TOGA Central

Response to Submission

TOGA

November 2022

Ground floor plan - revised design

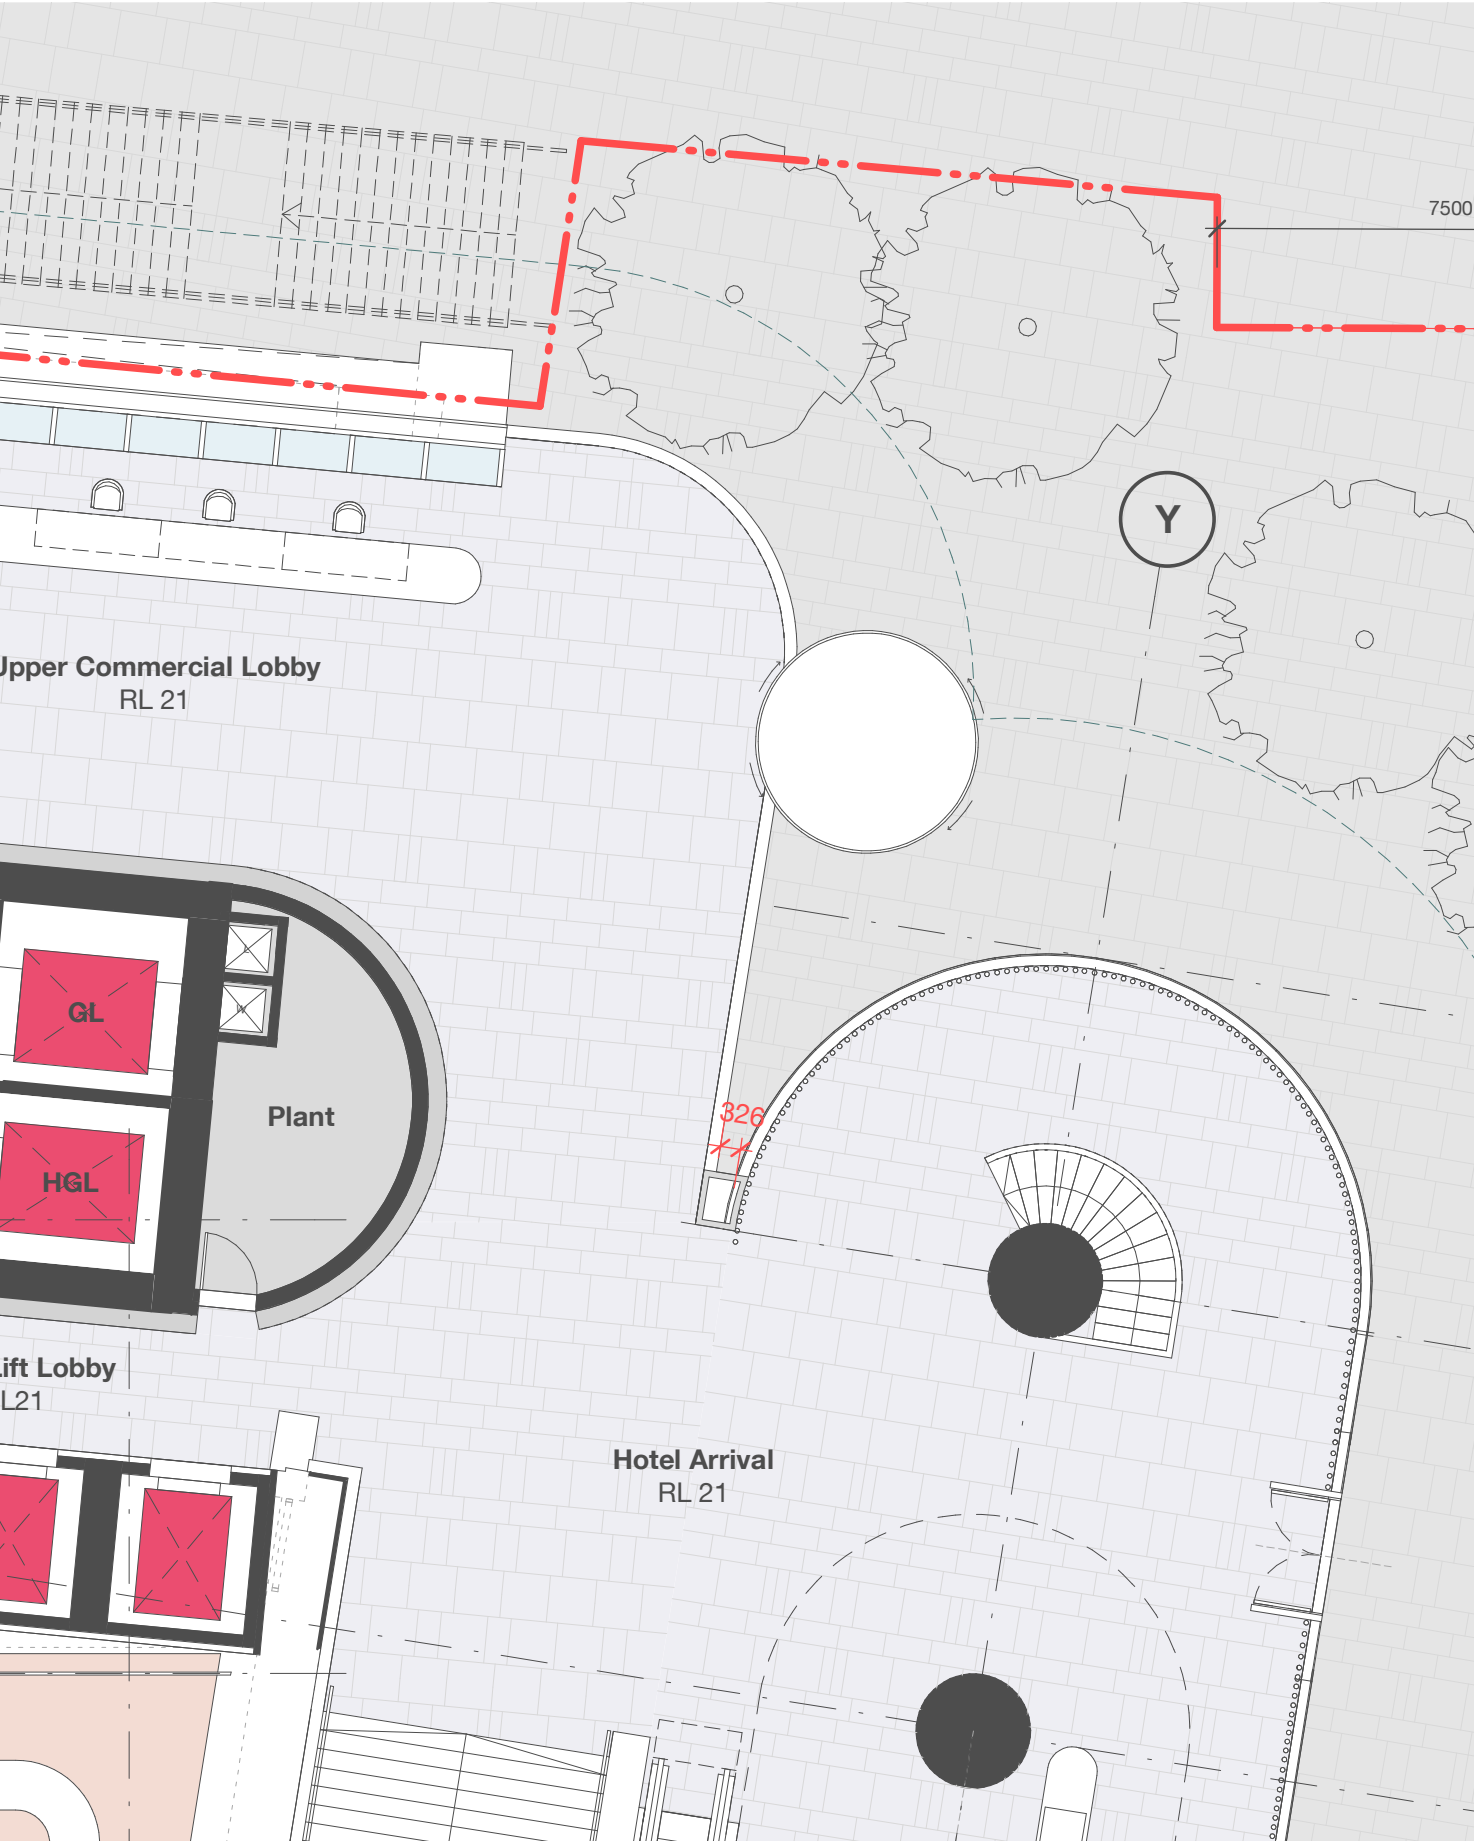
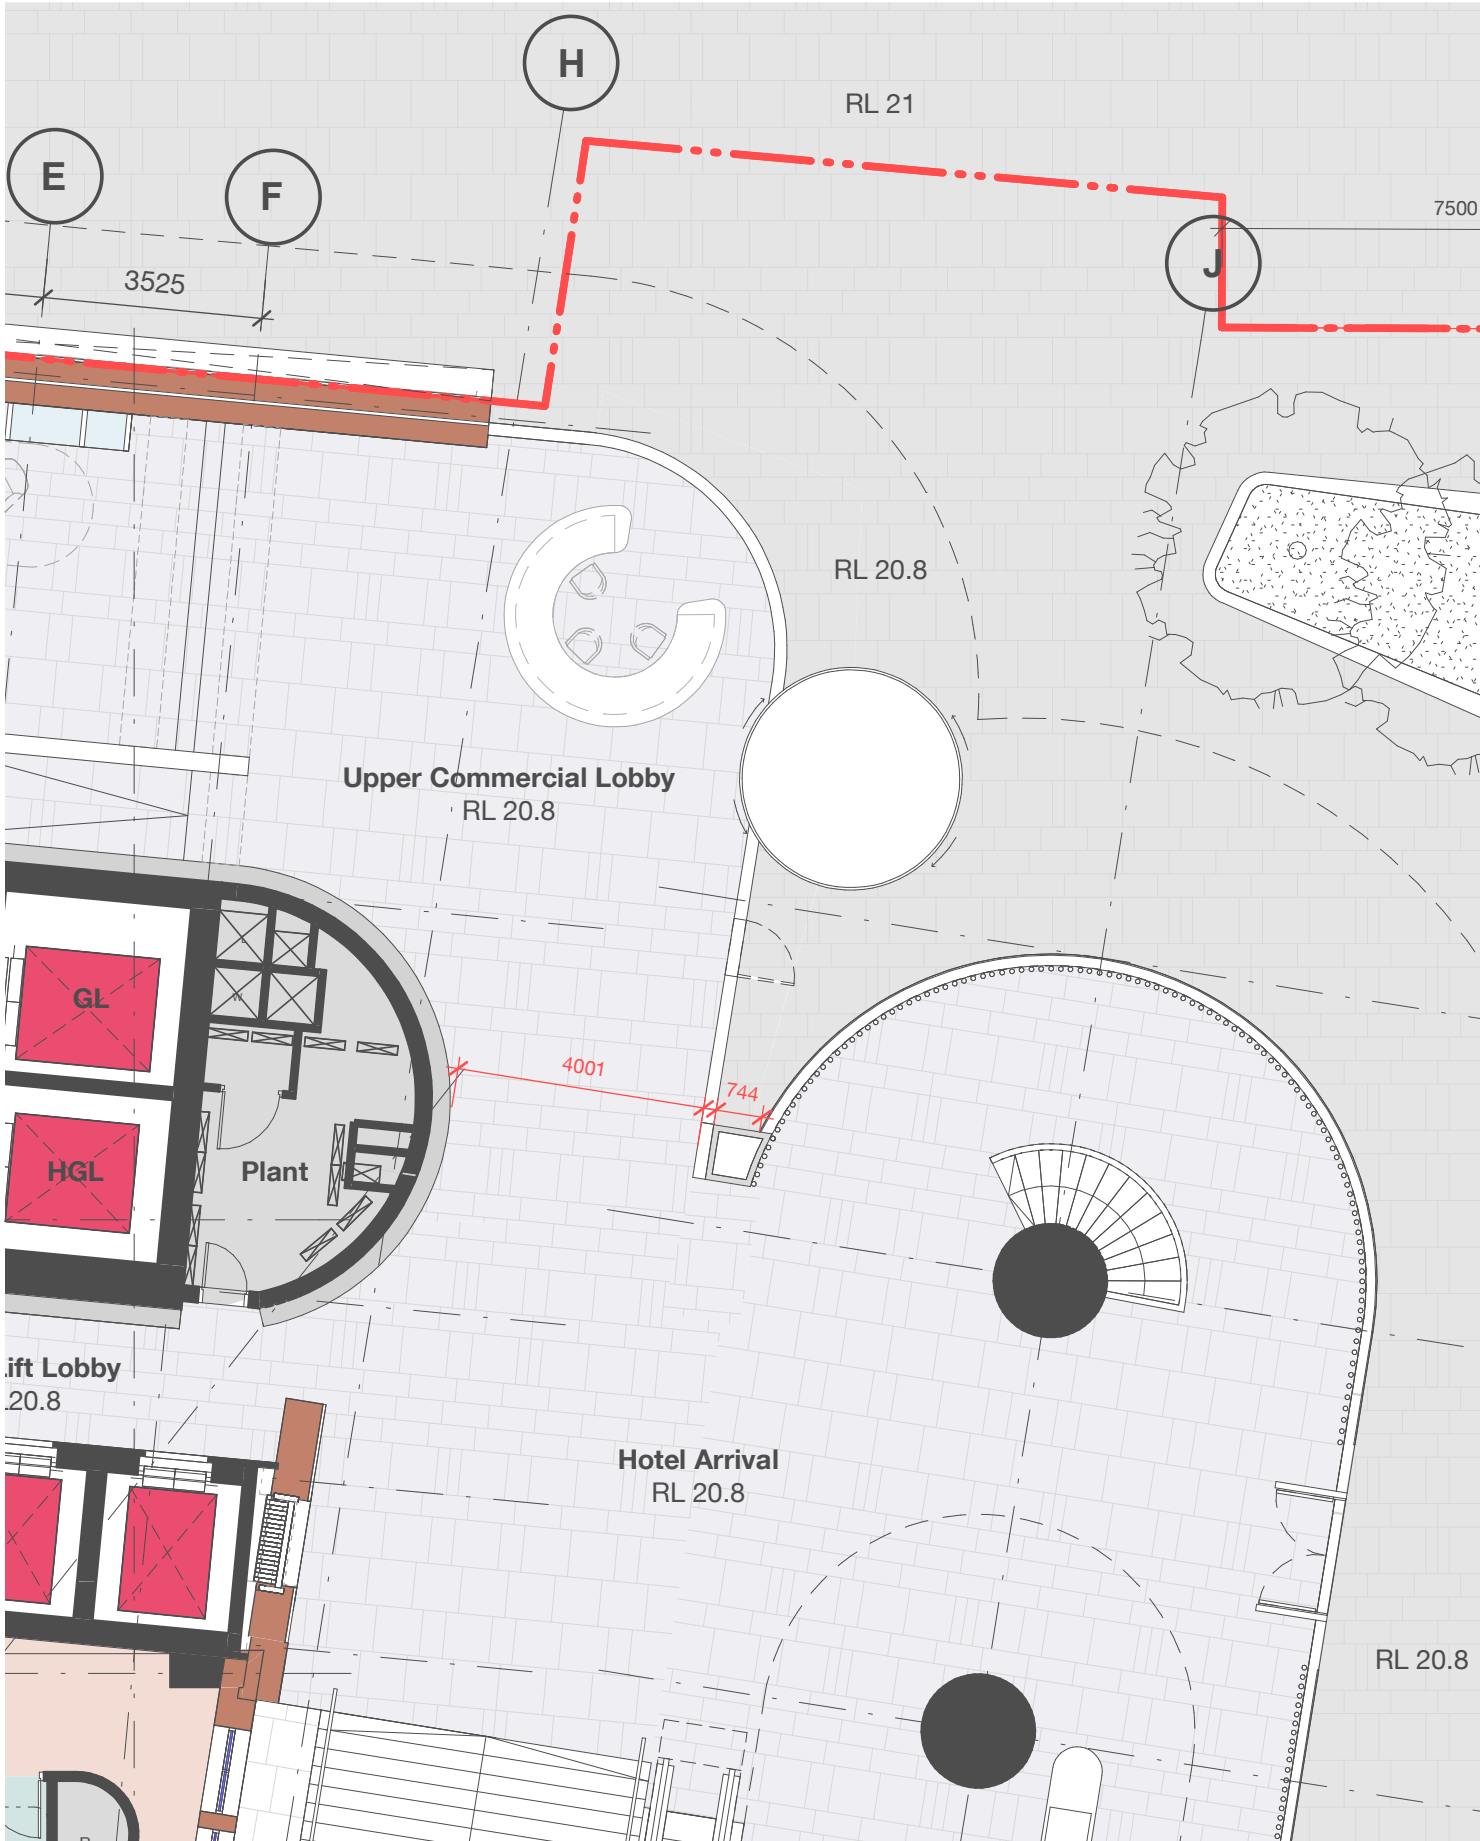
d) resolution of the proposed dead spaces located between the Henry Deane Plaza stairs fronting Lee Street and the glazed tower atrium and between the eastern and southern 'pill' buildings (Figure 2).

The recess separating the eastern lobby from the southern pill serves 2 functions. It houses structure supporting the glazed atrium above and conceals a downpipe for rainwater collection from the glazed roof. It also allows the southern pill tower form to be brought down to the ground with clarity in the architectural expression of each pill shaped form.

We agree that the previous version of this recess shown in the SSDA submission created a tight notch that was inaccessible. This has been amended in our RTS submission with the width now more than doubled from 326mm to 744mm. It has also been moved further east to allow for better accessibility and visibility into the space.

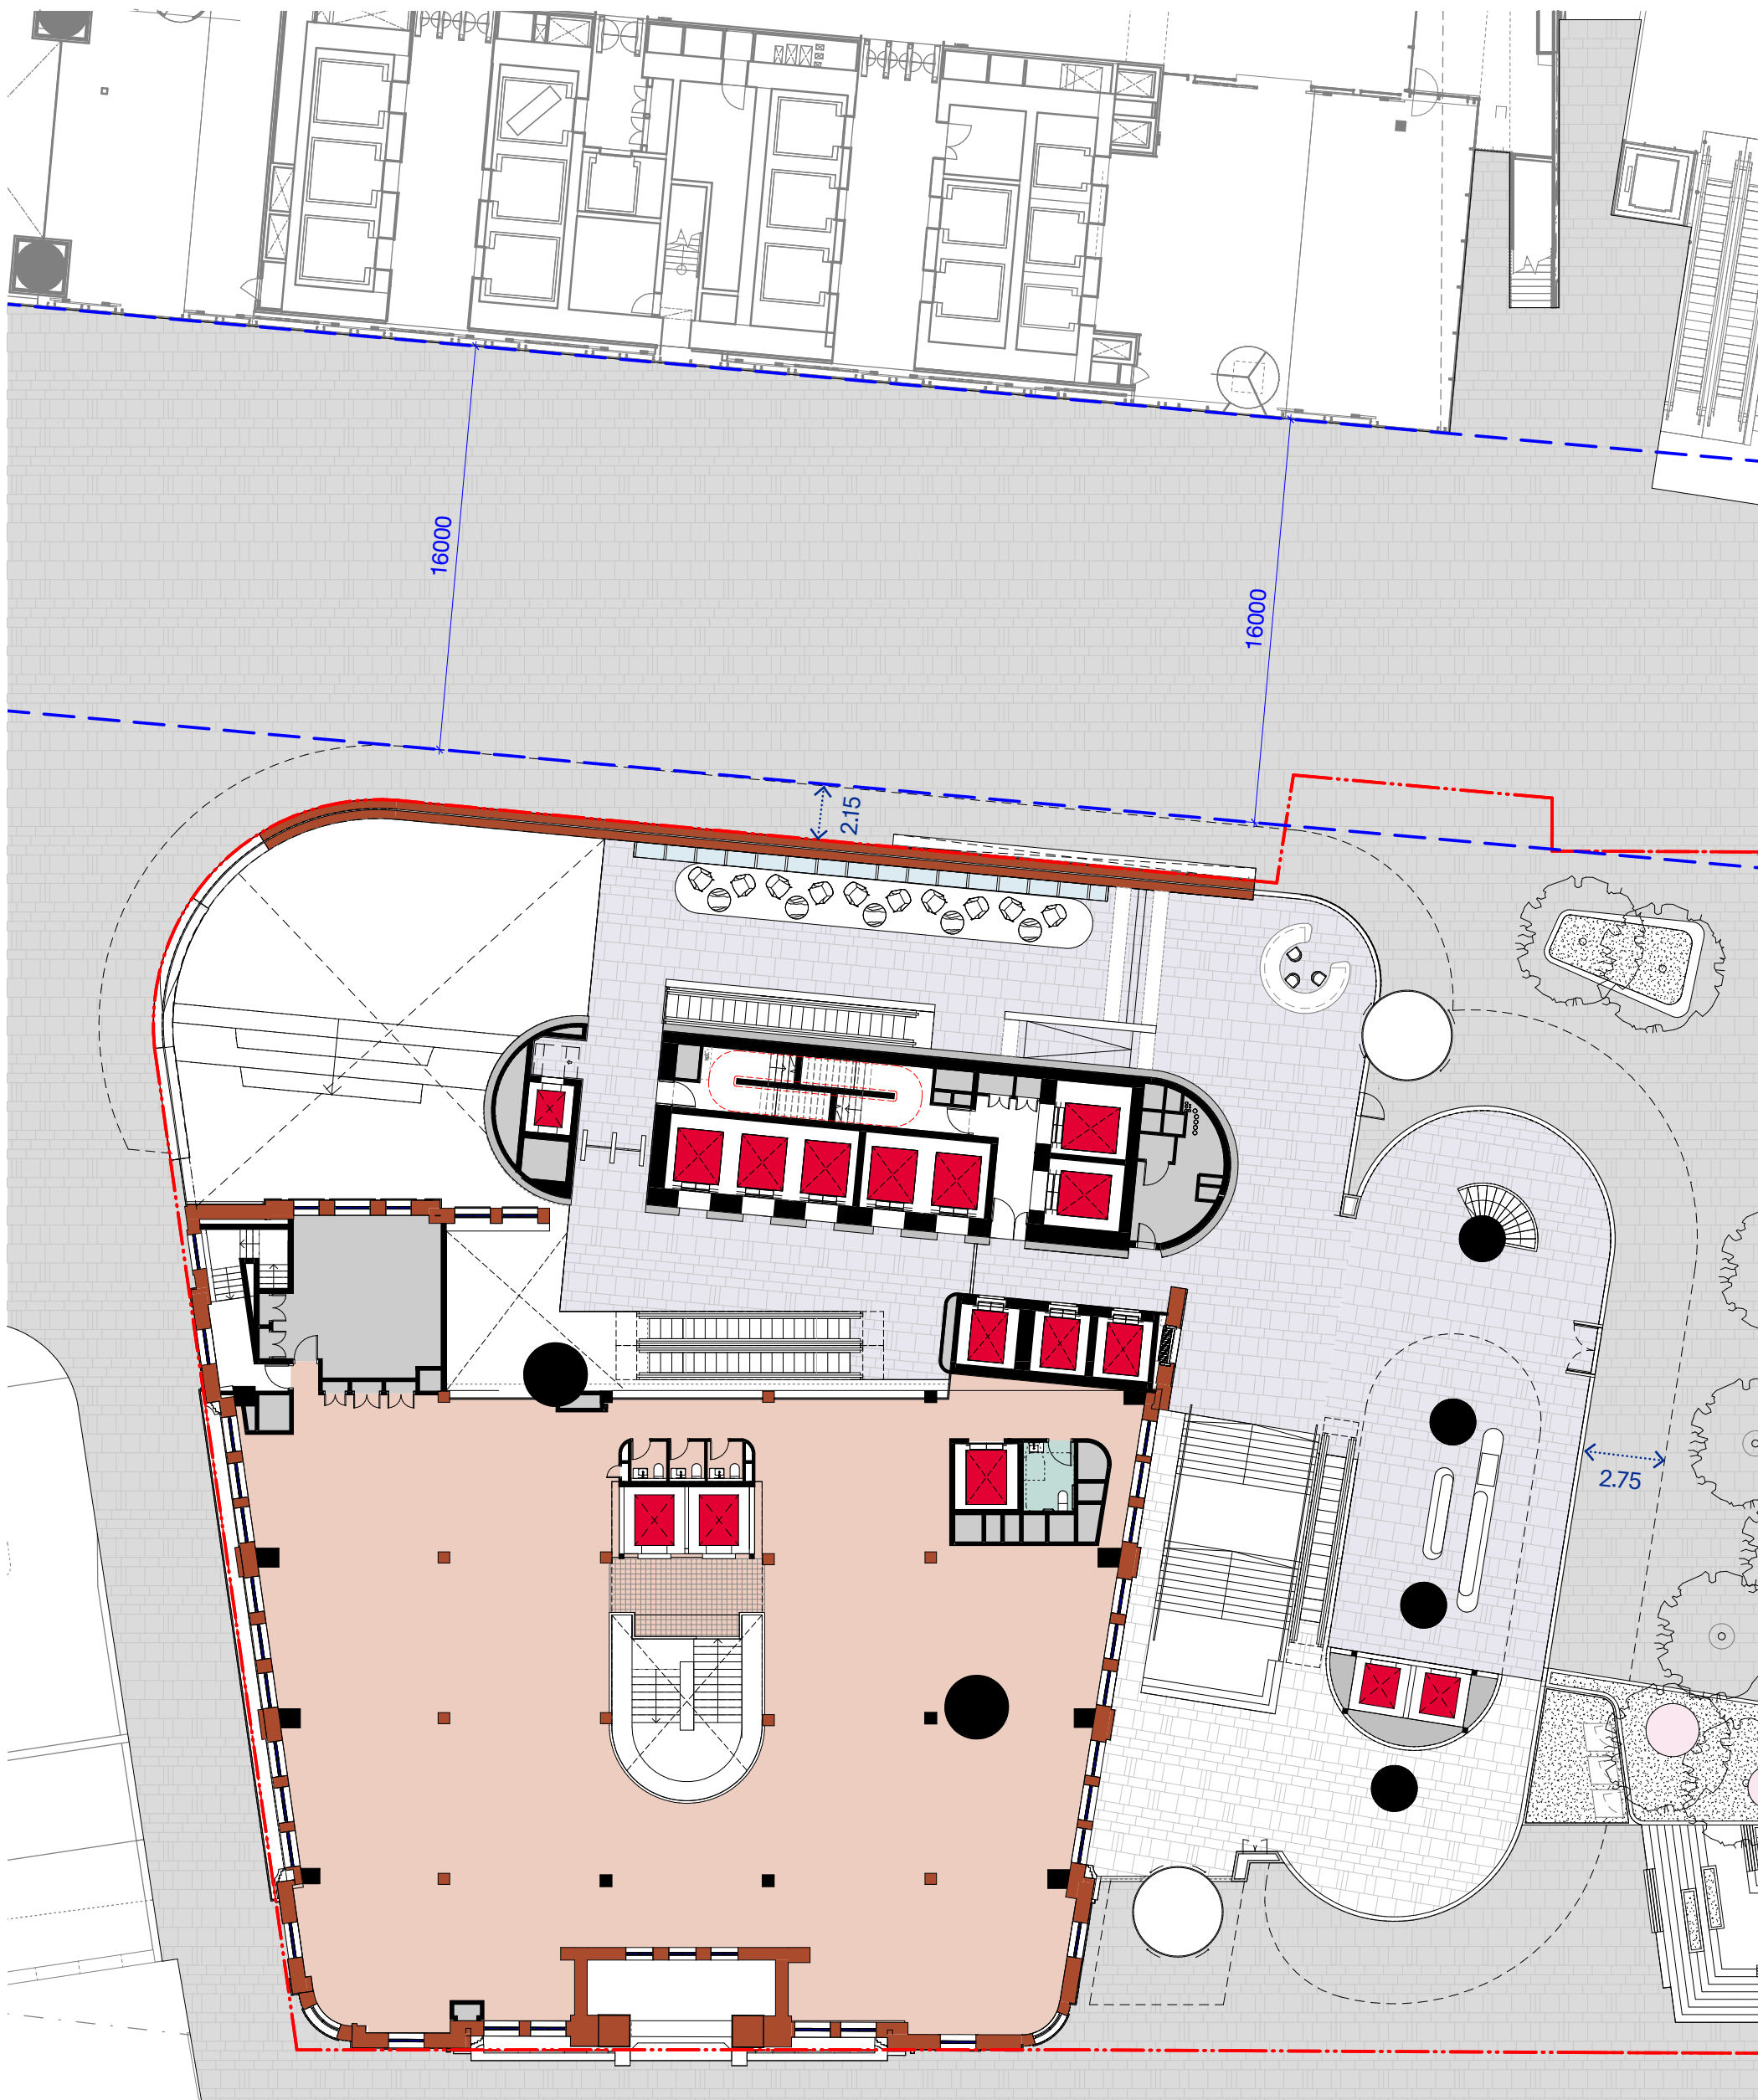
Clarify the design and location of the proposed building awnings, including:

- a) drawing(s) confirming the extent to which the awning(s) exceed the building envelope (also see point 2); and
- b) the relationship and impact of the awning to Block A (Atlassian), including:
 - i) confirmation of how many metres the awning projects into Block A and over the Atlassian upper ground floor
 - ii) the height of the awning above the relevant public domain level on the site and on the Atlassian upper ground floor
 - iii) any impacts to the approved landscaping (noting the awning is located above proposed Atlassian tree planting and landscaping)
 - iv) confirmation of consultation with, and agreement from Atlassian for the projection of the awning over the Block A, Upper Link Zone.

- a) The eastern awning extend 2.15m beyond the eastern property boundary with Block A, and is contained within the 16m eastern setback line. The southern awning extends 2.75m beyond the southern pill setback line.
- b) i) The awning is ca 16m setback from the Atlassian development (Block A and Block C are not 100% parallel) and is compliant with the required 16m setback.

- b) ii) The awning is set at 5.8m above RL 21.
- b) iii) and iv) Toga are aware of the use of trees, slab openings to RL 16 and introduction of a DDA lift in the link zone. These items were discussed with Atlassian, but no concerns were raised in coordination meetings between the two parties. Please refer to formal letter from Atlassian provided separate to this document.
